Central Fire Station

City of Everett ADA Transition Plan

June 2018

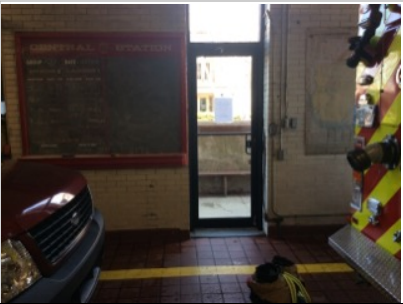
ID	Location	Element	Type	Photo	Issues	Current Measure	Recommendations	Quantity	Price	Cost Estimation	
Pedestrian Access Routes											
Walking Surface											
1	School St. to Broadway	Walking Surface	Sidewalk		Running slope > 1:20 (5.00%) Cross slope > 1:50 (2.00%) Beveled changes in level > 1/2"	6.7% 7.6% 2"	Reduce running slope to be no steeper than 1:20 (5.0%). Reduce cross slope to be no steeper than 1:50 (2.00%). Alter surface so that bevel height is 1/4" min.	1	448	\$448	
Street Crossing											
2	School St. and Corey St.	Street Crossing	N/A		Surface not stable, firm, and slip-resistant	-	Repair surface.	1	103	\$103	
Curb Ramps and Blended Transitions											
Diagonal Curb Ramp											
3	School St. and Corey St.	Diagonal Curb Ramp	N/A		Running slope > 1:12 (8.33%) Detectable warning not provided	13.5% -	Provide a detectable warning on the curb ramp. Reduce running slope to be no steeper than 1:12 (8.33%).	1	1405	\$1405

Perpendicular Curb Ramp											
4	School St. and Corey St.	Perpendicular Curb Ramp	N/A		Running slope is > 1:12 (8.33%) Transition from curb ramp to street is not flush Detectable warning not provided	11% 1" -	Reduce running slope to be no steeper than 1:12 (8.33%). Ensure transition from curb ramp to street is flush or free of changes in level. Provide a detectable warning on the curb ramp.	2	1490	\$2980

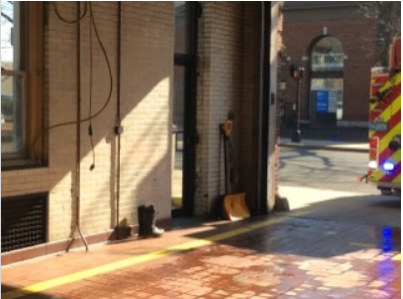
ID	Location	Element	Type	Photo	Issues	Current Measure	Recommendations	Quantity	Price	Cost Estimation	
5	Broadway	Perpendicular Curb Ramp	N/A		Landing > 1:50 (2.00%) Detectable warning not provided	5.2% -	Reduce slope to be no steeper than 1:50 (2.00%). Provide a detectable warning on the curb ramp.	2	303	\$606	
6	Broadway and Corey St.	Perpendicular Curb Ramp	N/A		Surface not stable, firm and slip-resistant Detectable warning not provided	- -	Repair surface. Provide a detectable warning on the curb ramp.	1	283	\$283

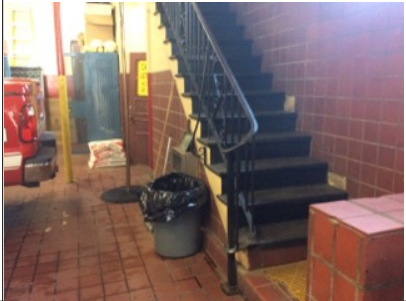
ID	Location	Floor	Room	Element	Type	Photo	Issues	Current Measure	Recommendations	Quantity	Price	Cost Estimation
Approach and Entrance												
Exterior Access Route												
7	Route to Entrance Door	1		Exterior Access Route	Walkway		Obstructed by protruding objects	8"	Relocate mailbox.	1	Labor	\$0
8	Route to Entrance Door	1		Exterior Access Route	Walkway		Surface openings > 1/2"		Replace or reposition so that openings are 1/2" max. and the long opening dimension is perpendicular to the dominant direction of travel.	1	1367	\$1367
9	Step Leading to Entrance and Exit Doors	1		Exterior Access Route	Walkway		Surface openings > 1/2"		Replace or reposition so that openings are 1/2" max. and the long opening dimension is perpendicular to the dominant direction of travel.	1	1367	\$1367
10	Step Leading to Entrance and Exit Doors	1		Exterior Access Route	Walkway		Level changes > 1/4"	6.5"	Alter change in level to be 1/4" high max. Consider installing a temporary metal ramp to provide an accessible entry route to the building. (Cost is for a 7' perforated metal ramp with a 5' x 5' platform courtesy of Amramp). N.B.: It is crucial that drainage be addressed with this design.	1	2800	\$2800

Entrance												
11	Main Entrance with Bell	1		Entrance	Main Entrance		Entrance not on an accessible route Clear width at door is < 32"	- 29"	Widen the door so that there is 32" min. clear width.	1	1683	\$1683

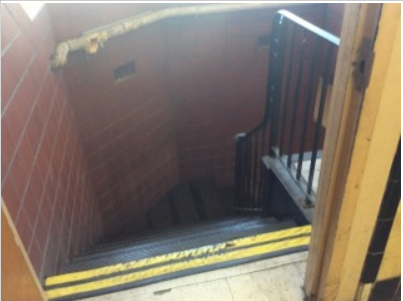
ID	Location	Floor	Room	Element	Type	Photo	Issues	Current Measure	Recommendations	Quantity	Price	Cost Estimation
Emergency Exit												
12	Exit by Truck Door	1		Emergency Exit	N/A		Emergency exit not on an accessible route Clear width at door < 32" Maneuvering clearance not provided at recess > 8"	3.4" 29" 12"	Widen the door so that there is 32" min. clear width. Install an automatic door opener. Try to address the 3.4" change in level at the door with the exterior ramp described previously.	1	3213	\$3213
13	Main Entrance with Bell	1		Emergency Exit	N/A		Emergency exit not on an accessible route Maneuvering clearance not provided at recess > 8"	- 12"	Install an automatic door opener.	1	1530	\$1530
Access to Goods and Services												
Interior Access Route												
14	Accessible Entrance Circulation Route	1		Interior Access Route	N/A		Route < 36" wide	26"	Ensure that a clear width of 36" min. is maintained at the accessible route. Currently the only accessible route in is by way of the fire door but when a truck is parked here the route narrows to 26" clear.	1	Labor	\$0

Doors, Doorways, & Gates												
15	Toilet Room	1		Doors, Doorways, & Gates	Toilet Room		Clear width at door < 32"	30"	Use offset hinges to widen the door so that there is 32" min. clear width.	1	1116	\$1116
